UNITED STATES  
DEPARTMENT OF THE INTERIOR  
BUREAU OF LAND MANAGEMENT

FORM APPROVED  
OMB NO. 1004-0135  
Expires: July 31, 2010**SUNDRY NOTICES AND REPORTS ON WELLS**  
*Do not use this form for proposals to drill or to re-enter an abandoned well. Use form 3160-3 (APD) for such proposals.***SUBMIT IN TRIPLICATE - Other instructions on reverse side.**

1. Type of Well <input checked="" type="checkbox"/> Oil Well <input type="checkbox"/> Gas Well <input type="checkbox"/> Other		8. Well Name and No. TONY FEDERAL 43
2. Name of Operator APACHE CORPORATION		9. API Well No. 30-015-40388-00-X1
3a. Address 303 VETERANS AIRPARK LANE SUITE 3000 MIDLAND, TX 79705	3b. Phone No. (include area code) Ph: 432.818.1167	10. Field and Pool, or Exploratory CEDAR LAKE
4. Location of Well (Footage, Sec., T., R., M., or Survey Description) Sec 19 T17S R31E Lot 1 1140FNL 330FWL		11. County or Parish, and State EDDY COUNTY, NM

**13-5/8" 3M psi  
BOPE & Choke Manifold  
EXHIBIT 3**

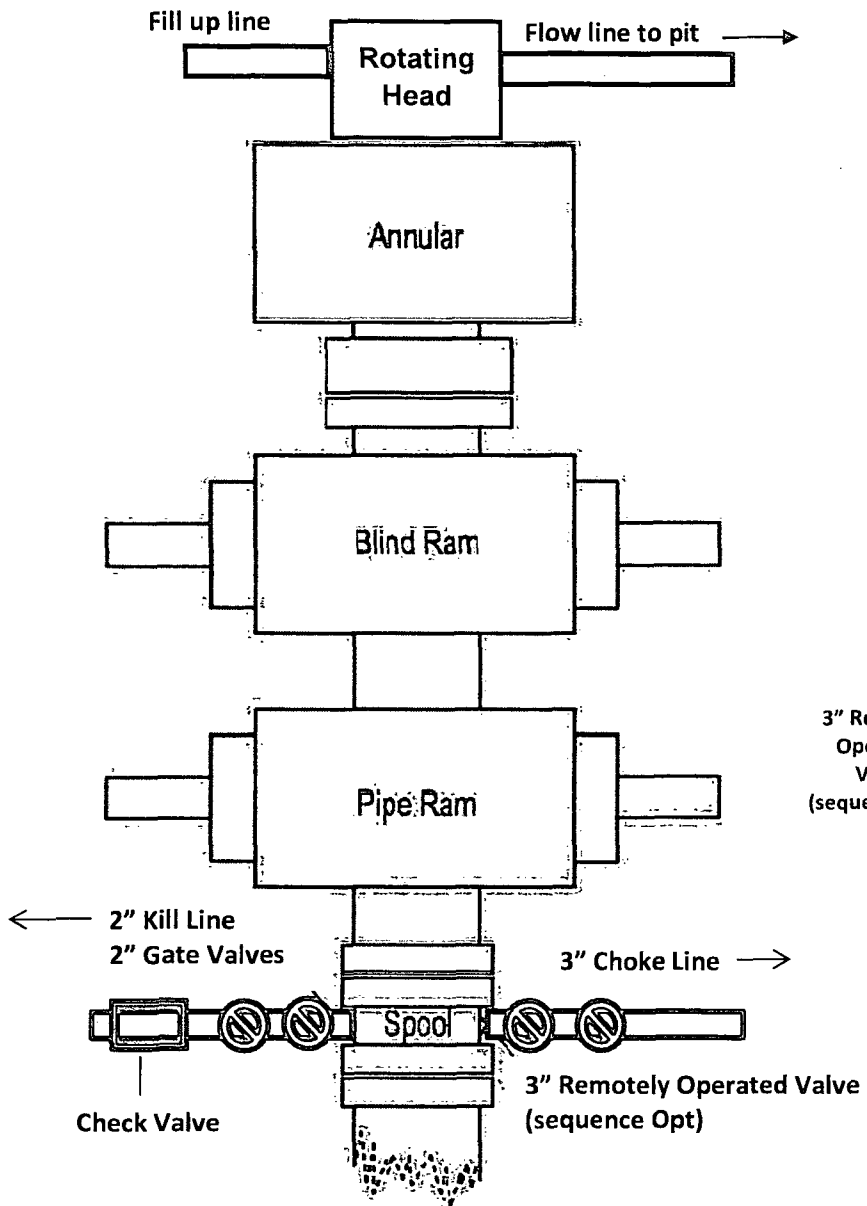
Apache Corporation proposes to use a 13-5/8" 3M psi WP BOP (EXHIBIT 3) consisting of an annular bag type preventer. The BOP will be nipped up on the 13-3/8" surface csg head & tested to 2000psi using a test plug. After intermediate csg is set & cemented a 13-5/8" or a 11" 3M BOP consisting of an annular bag type preventer, middle blind rams, and bottom pipe rams (see EXHIBIT 3A) will be installed & utilized continuously until TD is reached. The BOP will be tested at 2000 psi (maximum surface pressure is not expected to exceed 2M psi). BHP is calculated to be approximately 2819 psi. All BOPs & associated equipment will be tested as per BLM Drilling Operations Order #2. The BOPs will be operated and checked each 24 hr period & the blind rams will be operated & checked when the drill pipe is out of the hole. Functional tests will be documented on the daily driller's log. EXHIBITS 3 & 3A also show a 3M psi choke manifold with a 3" blow down line. Full opening
